Coastal Access – Combe Martin to Marsland Mouth lengths CMM1 to CMM3, CMM5 to CMM7, CMM9 and CMM10

Representations with Natural England's comments

January 2021

1) Access at Down End/Cock Rock

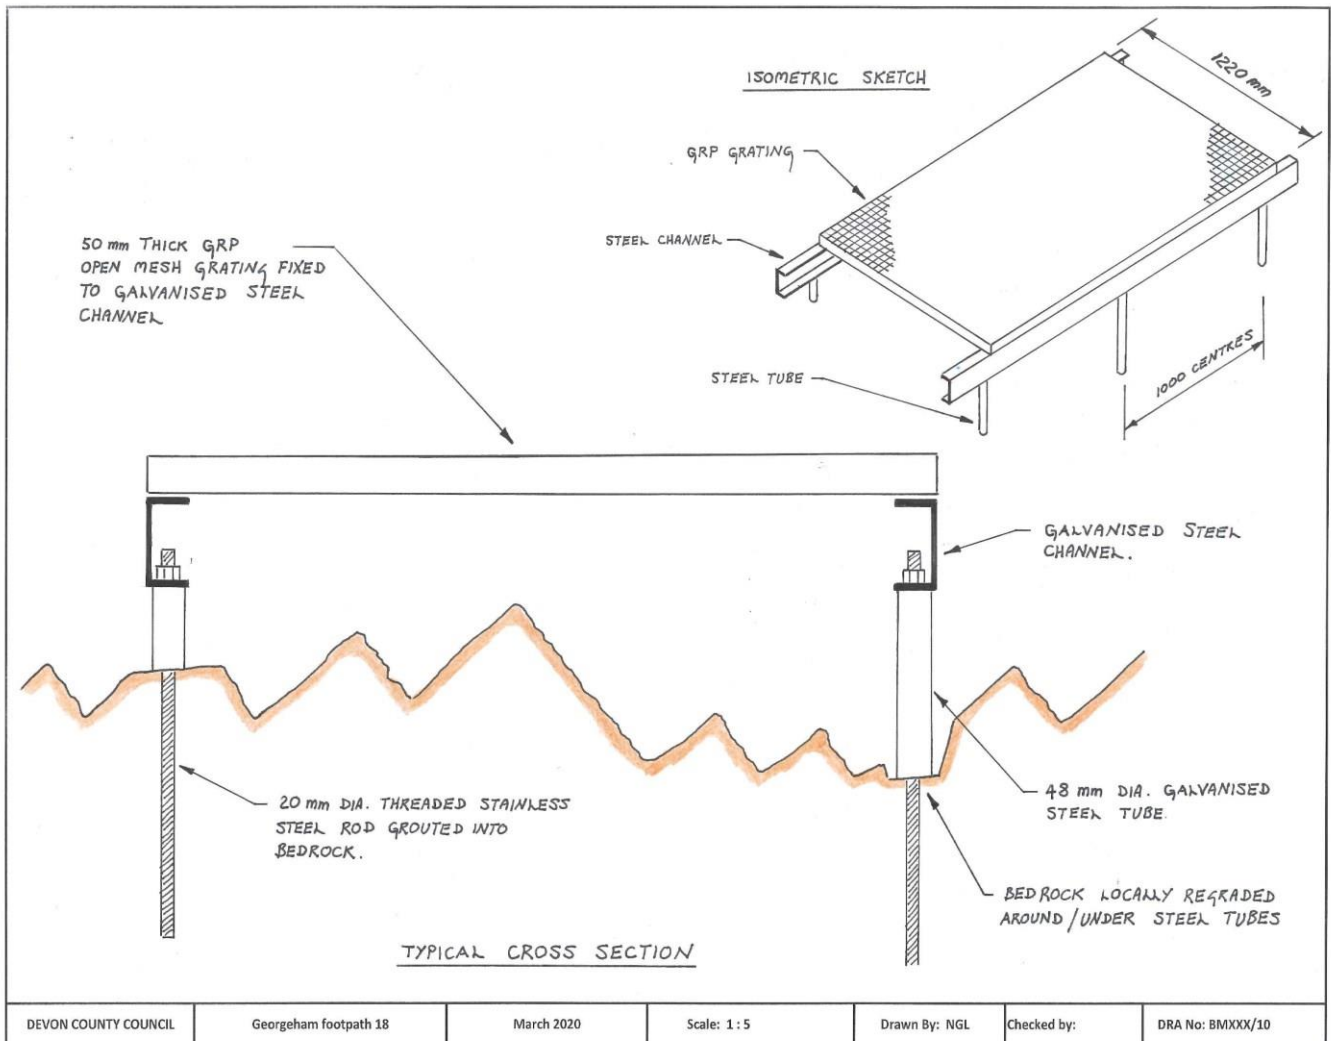
Previous discussions between local interest groups (SWCPA, Devon Council rights-of-way and the Ramblers Association) and Natural England on how to improve access resulted in a disappointing negative response from Natural England.

The [redacted] and [redacted] representations comment on the proposed 'inland' alternative route and its potential impact on the sensitive habitats. They say that by encouraging walkers to use the alternative route, they may leave the path – especially in the vicinity of route section CMM3-A001. Croyde Burrows is a healthy system of sand dunes supporting many species, and is important in connecting areas of dunes along the coast. For example the rare brown-banded and moss carder bees present at Braunton Burrows, have recently been spotted in Croyde and on Baggy Point SSSI land and work is on-going to actively protect these potential new habitats. [Redacted] also suggests that the inland alternative route would lead to property owners erecting fences to stop the increase in loss of privacy. It would also probably increase the installation of unsightly wooden fences that are not a vernacular to the area and that the proposed funds could be used to rectify the current unsatisfactory and unsafe section of the path.

The proposals to 'improve' the access over the rocks below Down End/Cock Rock have been discussed locally for some time. Devon Council Engineering Design Groups' preferred option at the site would be to reinstate the concrete walkway but they acknowledge that this would have the most impact on the SSSI. Their latest proposals (Feb 2020) are to use a raised metal grate 'Safegrid' type walkway. An initial design for such as walkway has been produced.

The line of the England Coast Path will use this route and we are expecting repairs to take place. Discussions are currently underway with Natural England specialists and the access authority about how best to take it forward.

CMM-3-S009

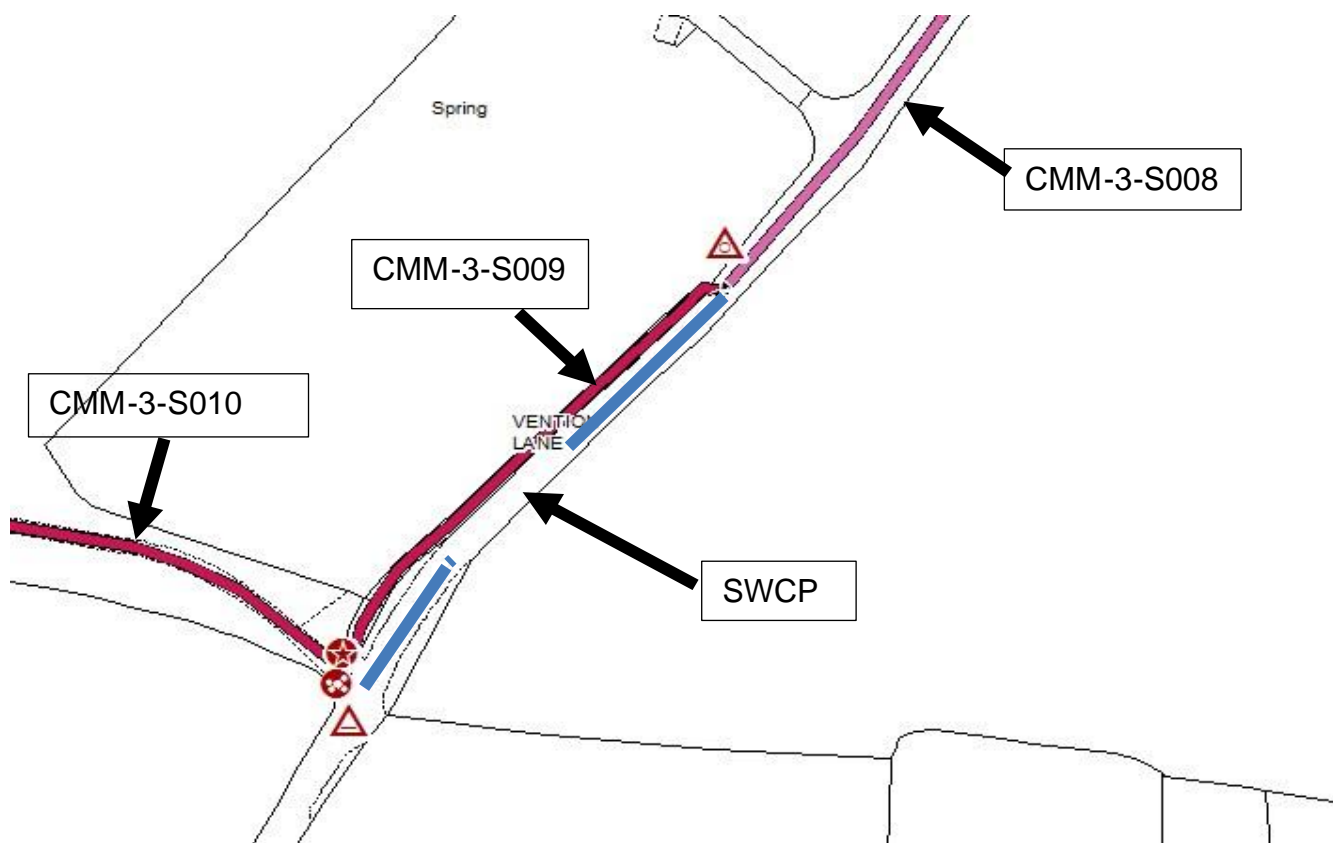
Proposed route currently shown on 'permissive path' immediately adjacent to the public highway/current route of the South West Coast Path. [Redacted] is content to provide this permissive route but does not want it to become the official England Coast Path route.

The relocating of the proposed ECP onto the road (route section CMM-3-S008 is already on the road) will make little difference to walkers and would answer [redacted]'s request that the permissive path would not become the official ECP route.

Our proposals currently show that route section CMM-3-S009 '*follows the existing South West Coast Path*' (Length Report CMM 3 Woolacombe to Cock Rock, Croyde table 3.3.1) i.e. the road.

Natural England agree to [redacted]'s proposed amendment that the ECP should continue to follow the current route of the SWCP because we judge that it would make very little practical difference to the ECP user. This would mean a minor adjustment to the published map – moving the route by 1-2 metres onto the road, adding the suffix RD to route section to CMM3-S009 and updating table 3.3.1 to show that the landward boundary of the coastal margin is Road (landward edge) as opposed to Path (landward edge). The directing of the route along the road at this location has been agreed by the local Devon Council rights-of-way officer.

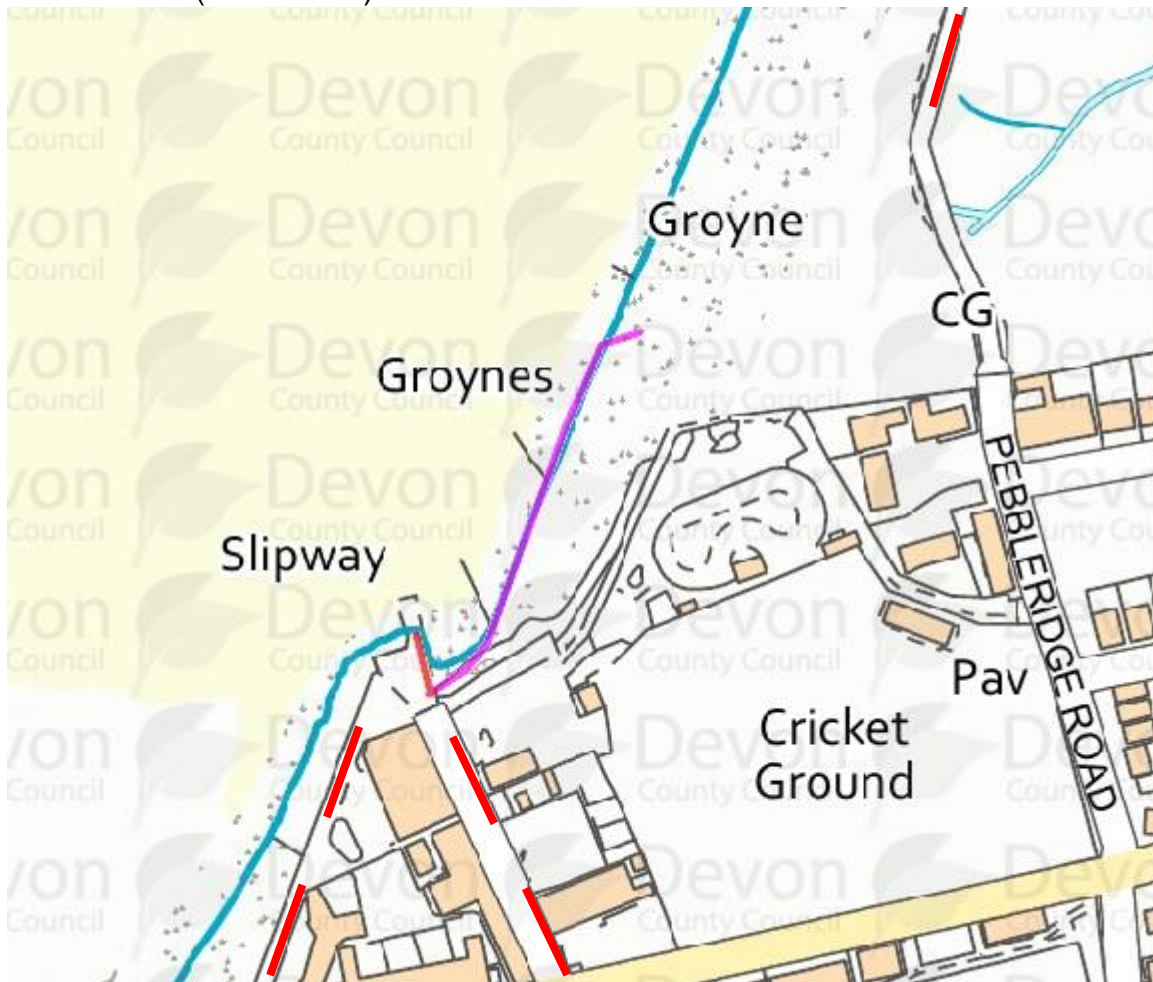
- 1. MAP CMM 7c Sections CMM-7-S048 to CMM-7-S052** and text in paragraphs 7.3.2 and 7.3.4. In relation to the “roll-back” at these sections and the possibility of a “new route landward” we are aware of a recent planning application which may be of relevance to any future re-routing.
- 2. MAP CMM 7f Sections CMM-7-S071 to CMM-7- S073** and text at paragraphs 7.2.5 and 7.3.2. We suggest that the inland routing of the trail around the cricket ground is unnecessary. . Any problems with the more direct route of the existing South West Coast

Path have been fairly minimal. The existing route is the more seaward and is preferable to the use of the public highway.

3. **MAP CMM 7f Sections CMM-7-S074 to CMM-7-S077** and text in paragraph 7.3.1. there appears to be some inconsistency between these sections as to “roll-back”. Is not roll-back applicable to all 4 of these sections since they appear to be similar terrain?

1. Natural England is also aware of the recent planning application for a development landward of route section CMM-7-S052 and the proposal to create a new ‘cut through’ from the current route of the South West Coast Path (SWCP) to the pavement along Torridge Road. The current route of the SWCP is a public footpath and the access authority have recently undertaken stabilisation work to secure the route of the path.
2. There are two routes seaward of the cricket ground at Westward Ho! One (magenta line) is a public footpath, the other (green dashes) is a ‘permissive path’ (and used to be the route of the SWCP). The proposed England Coast Path (ECP) follows the current SWCP route (red dashes).

3. No roll-back has been proposed for route sections CMM-7-S074 to CMM-7-S075 but has been proposed for CMM-7-S076 to CMM-7-S077. This is based on the National Coastal Erosion Risk Mapping short term (0-20 year) Shoreline Management Plan policy retreat distance indicating that, without active intervention, route sections CMM7-S076 to CMM-7-S077) may be lost to coastal erosion in the short term.

Fig 3 Existing Garage – via Goole Maps – showing old coast road / Newberry Close as a base.

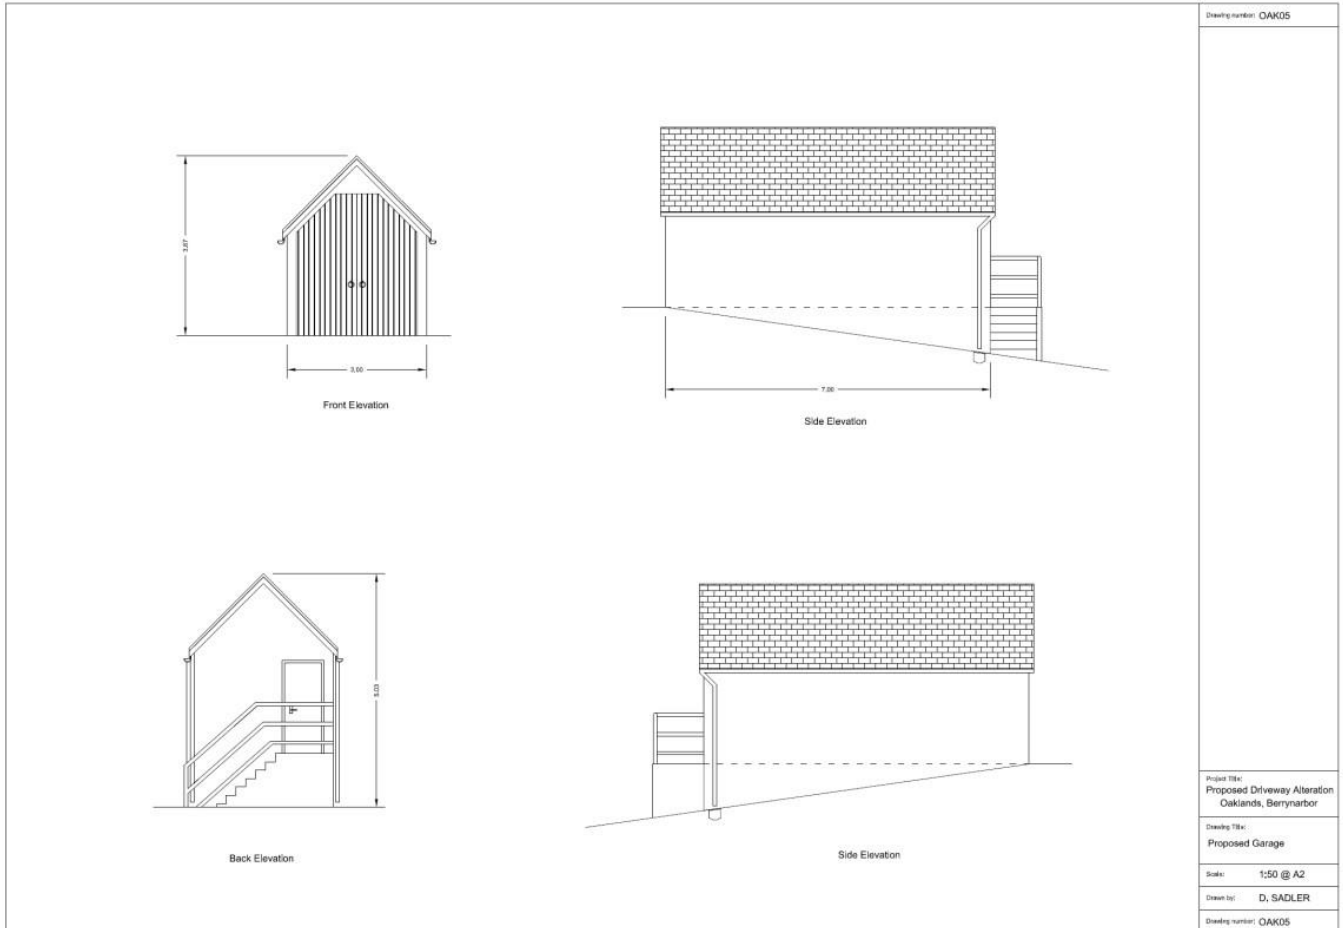
North Devon Council retrospectively awarded planning permission for a garage to be erected in April 2016 (NDCC Application 60766). This was awarded to the owners of the house named Oakland on Newberry Close. The finished building looks nothing like the proposal and is in a different location to the application, which seems a little bizarre. See Fig 3, 4 and 5. According to the Land Registry Title Deed, the land does not form part of the property and the coast path is shown as clear. The garage completely blocks the coast road.

Map 3d Baggy Point CMM-3-S014 to CMM-3-S019

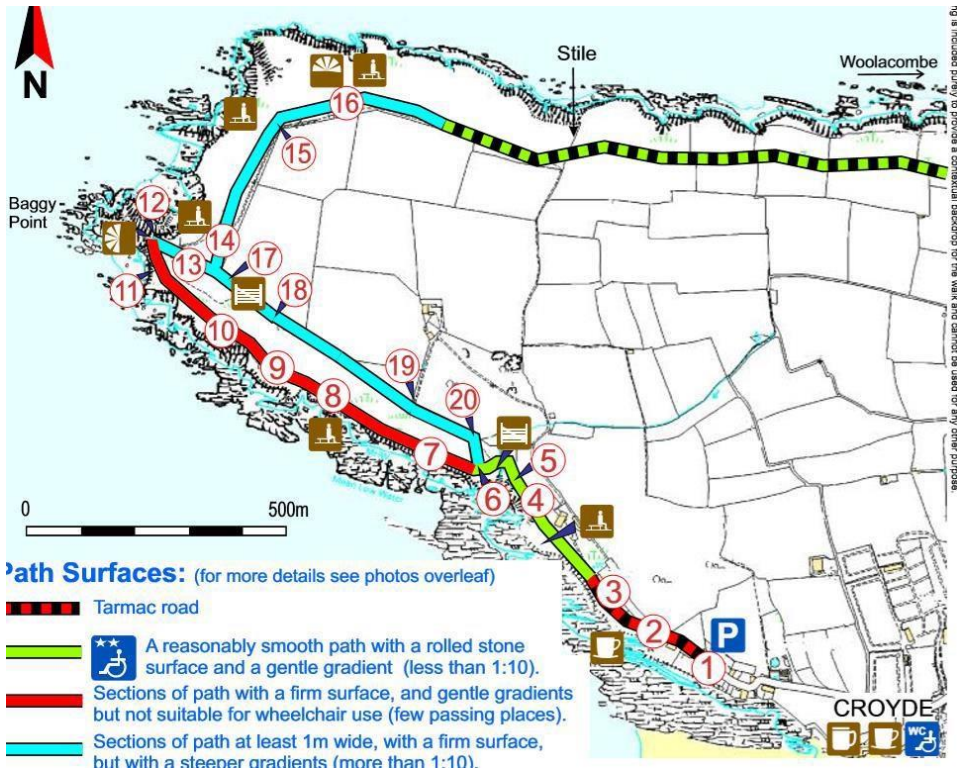
At the junction of route sections CMM-3-S013 and CMM-3-S014 there is a stile which should be replaced with a suitable pedestrian gate to allow access to users of mobility vehicles.

9g Paragraph

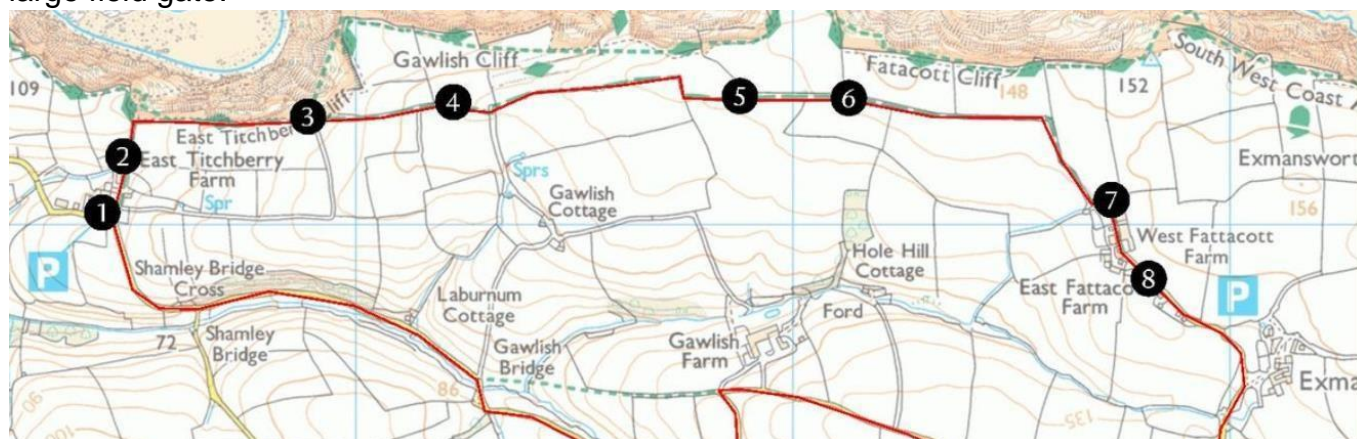
There are places where there are step stiles. Existing stiles between Mouth Mill and East Titchberry will be replaced, so as to make them easier to use. We envisage this happening before the new access rights come into force.

The terrain along the route of the Coast Path and the coastal margin landward of the trail on Maps 9e, 9f and 9g is suitable for users of all-terrain mobility vehicles and allows for a significant ramble. It is therefore encouraging that the existing step stiles will be replaced, but the new structures should be suitable for use by all-terrain mobility vehicles (see attached *Disabled Ramblers Notes on Infrastructure*).
